**ADDENDUM NO. 5  
NEW CREAMERY ROAD SEWAGE PUMP STATION  
CONTRACT NO. 001**

TOWN OF EMMITSBURG, MARYLAND  
 NEW CREAMERY ROAD SEWAGE PUMP STATION

DRAWING NUMBER  
**C2**  
 SHEET NO. 5 OF 60

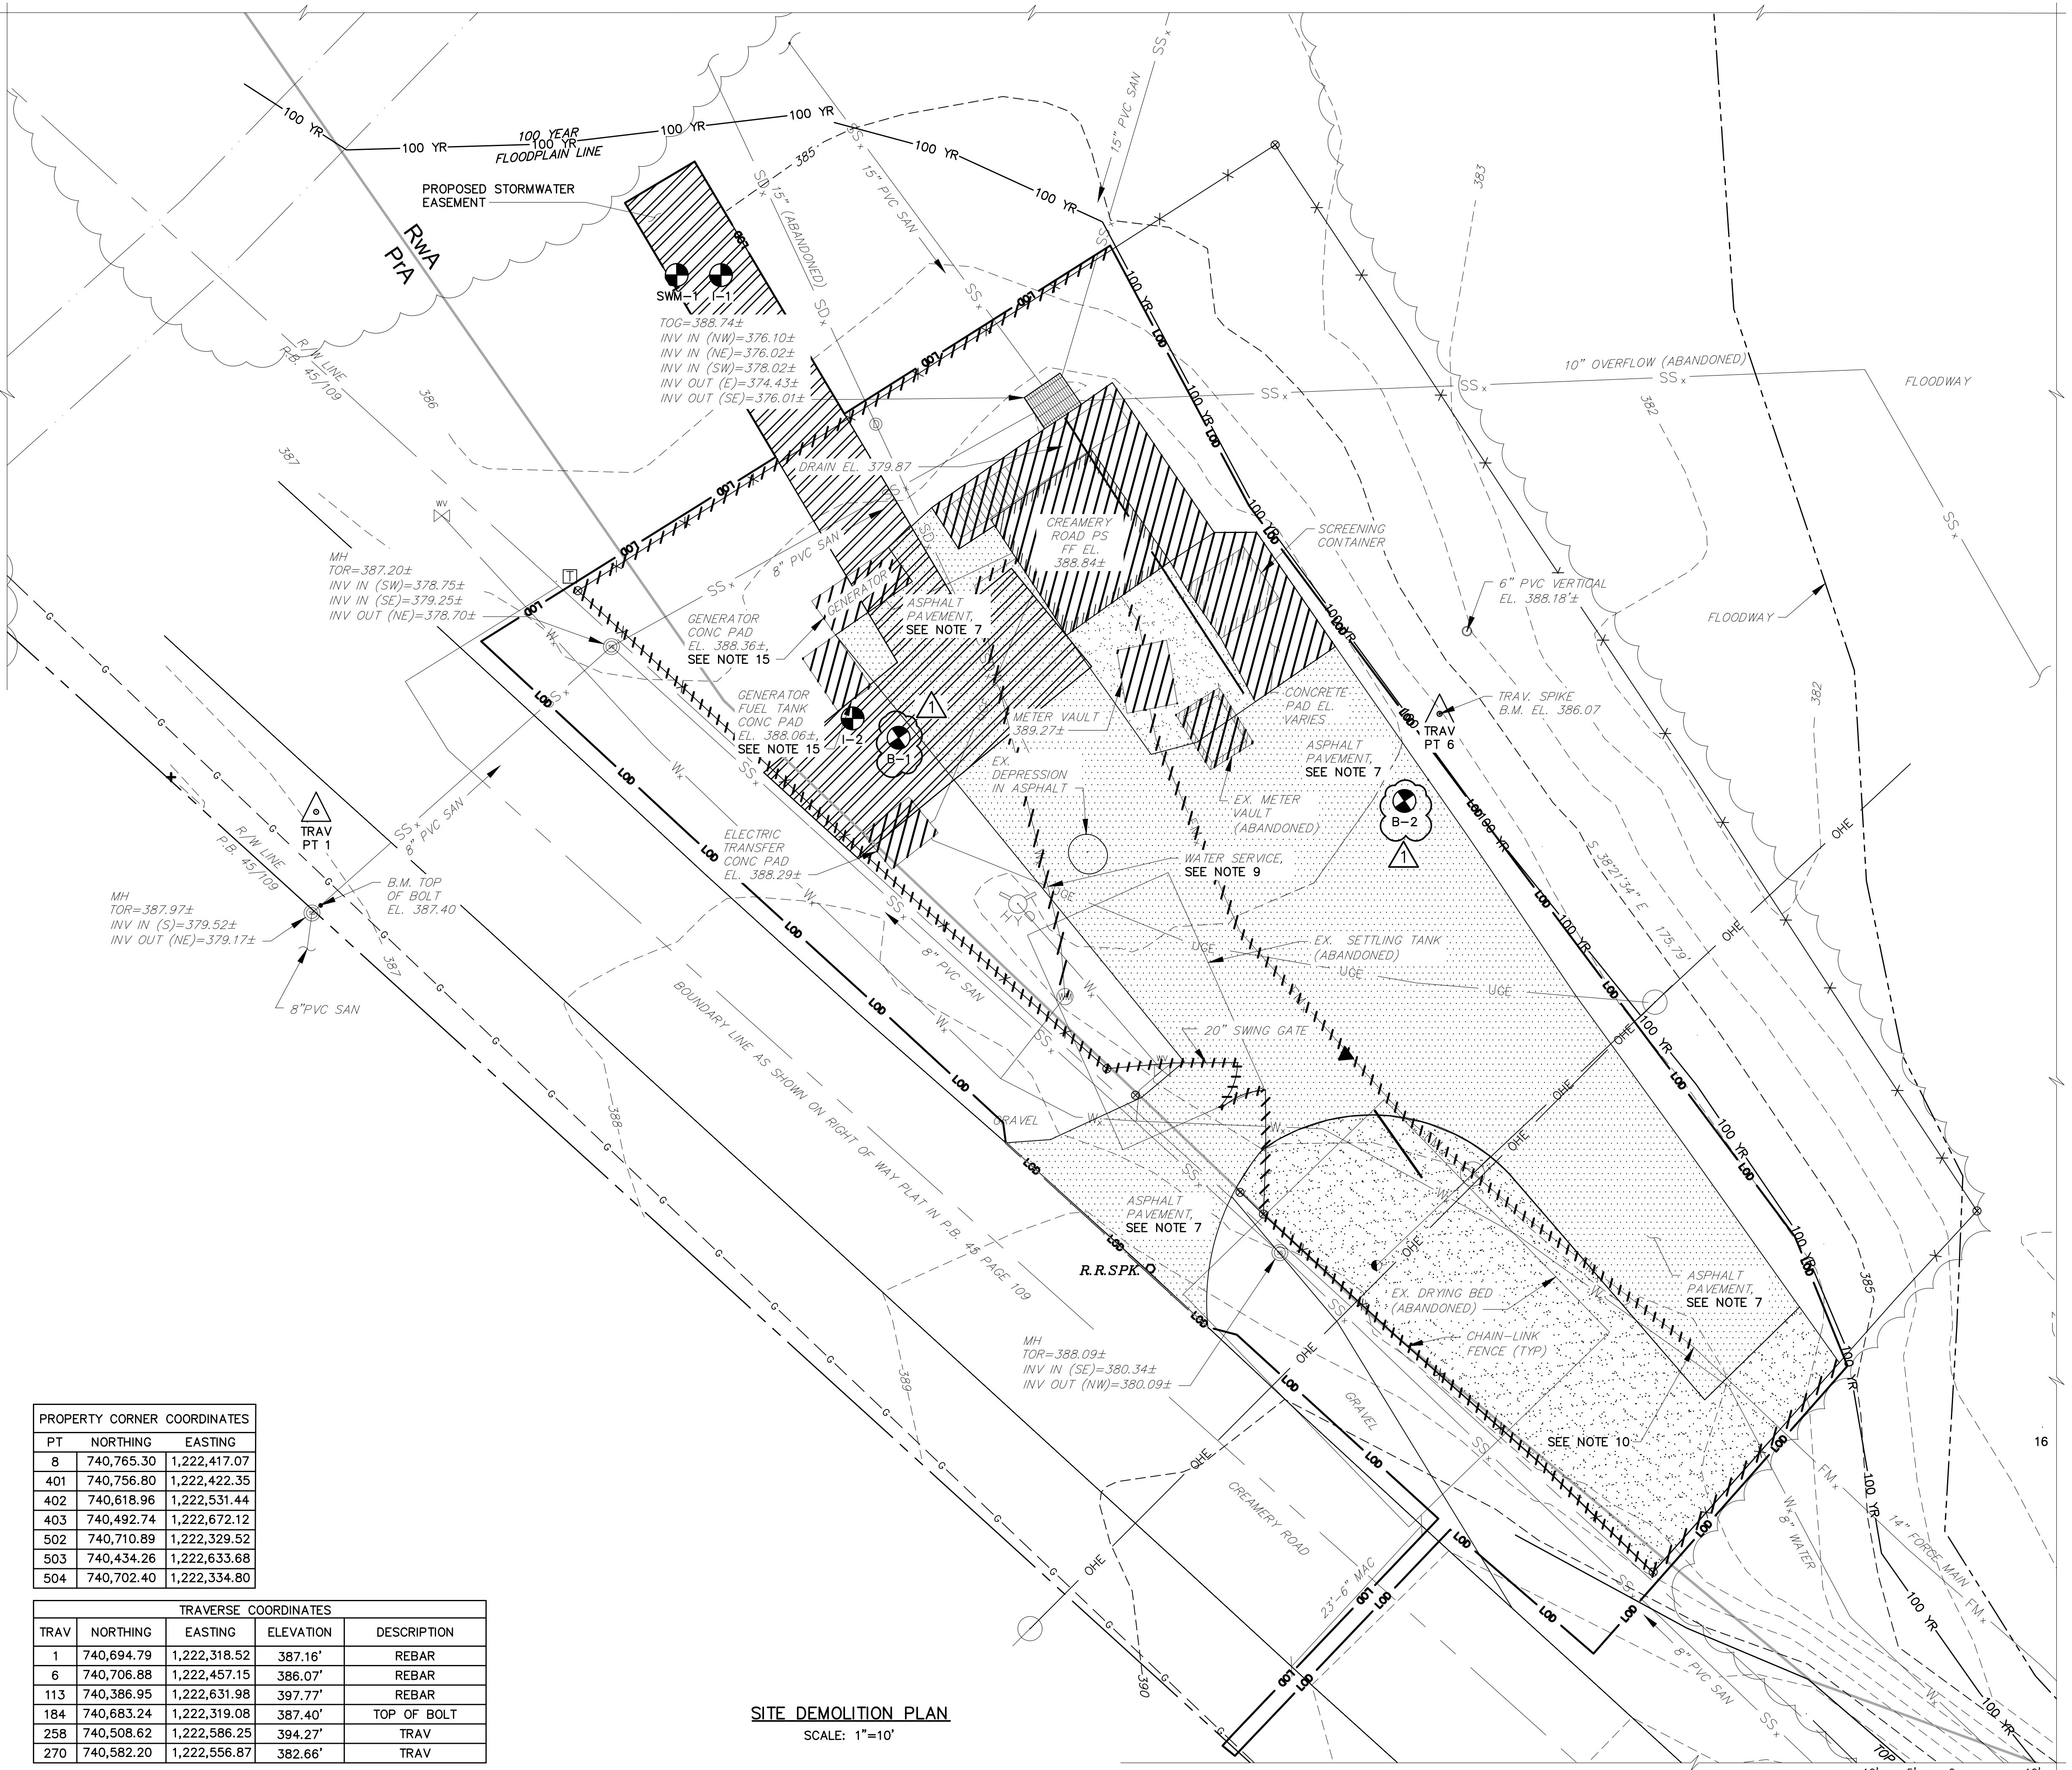
2. *Plan Sheet C2 shows the locations of Test Bores 505, 508, I1, I2, SWM 1. However, in the project manual we can only find Boring Logs for Borings B1 & B2. Please clarify the location on site of Borings B1 & B2, and also provide bore logs and soils information for all test pits/borings shown on plan sheet C2.*

10. *Does anything need done with the existing Settling Tank shown on plan sheet C2?*

11. *Does anything need done with the existing Drying Bed shown on plan sheet C2?*

**All test bores labeled 505 and 508 shall refer to Borings B-1 and B-2, respectively. See attached revised Sheet C2 and SWM-1. Bore logs/soils information for SWM-1 is attached. Infiltration rates for Borings I-1 and I-2 are also attached.**

**The Contractor shall consider the information provided on Sheet C2 regarding the existing settling tank and impacts on construction and include all associated costs within the bid to complete construction. Note that the settling tank has not been used as a settling tank since the pump station was built between 1986 and 1990.**

**The Contractor shall consider the information provided on Sheet C2 regarding the existing drying bed and impacts on construction and include all associated costs within the bid to complete construction. Note that the drying bed has not been used as a drying bed since the pump station was built between 1986 and 1990.**

**CONCRETE FLAT-PAD FOUNDATION  
PAD-MOUNTED TRANSFORMER 75 TO 500 KVA,  
THREE-PHASE, 34.5 KV & BELOW HIGH-SIDE**

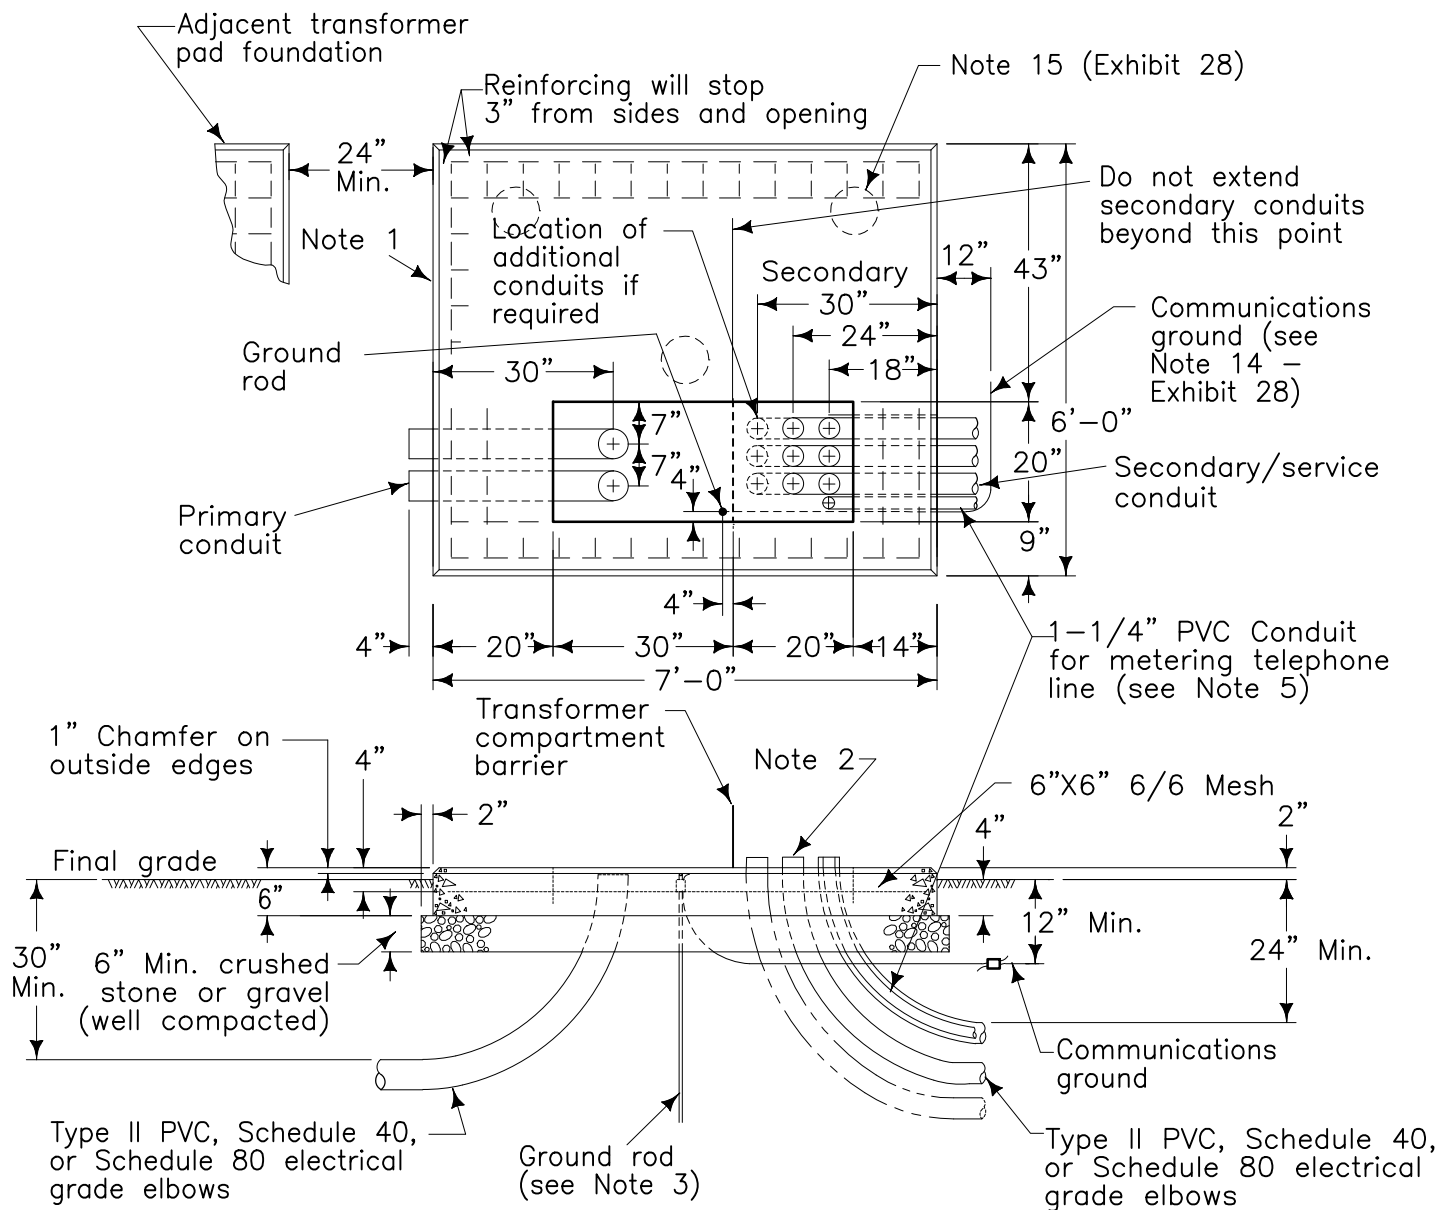
22. *Plan Sheet E2. Please provide the detail for the power company transformer pad referenced on Sheet E2, Note 2.*

**See attached standard detail for the power company transformer pad. The transformer pad shall be constructed in accordance with Potomac Edison requirements. Contractor shall coordinate with Potomac Edison for the transformer pad.**

# UTILITY TRENCH BACKFILL/PAVEMENT REPAIR DETAIL #1

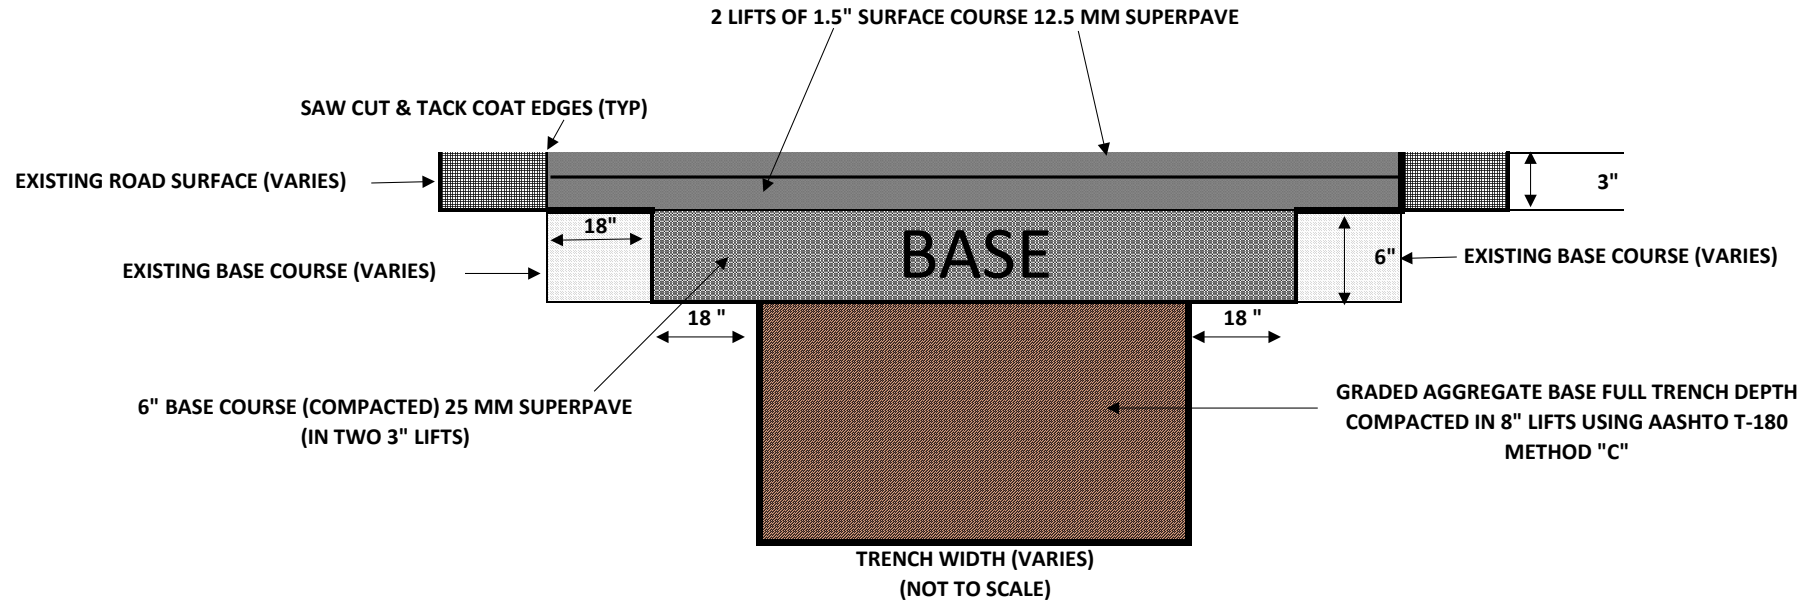
24. *Plan Sheet C3 Please provide a paving restoration detail for the gas line utility patch on Creamery Road.*

**Contractor shall refer to the Frederick County Utility Trench Backfill/Pavement Repair Detail #1 for Bituminous Concrete Roadways for the pavement restoration on Creamery Road. Detail attached.**
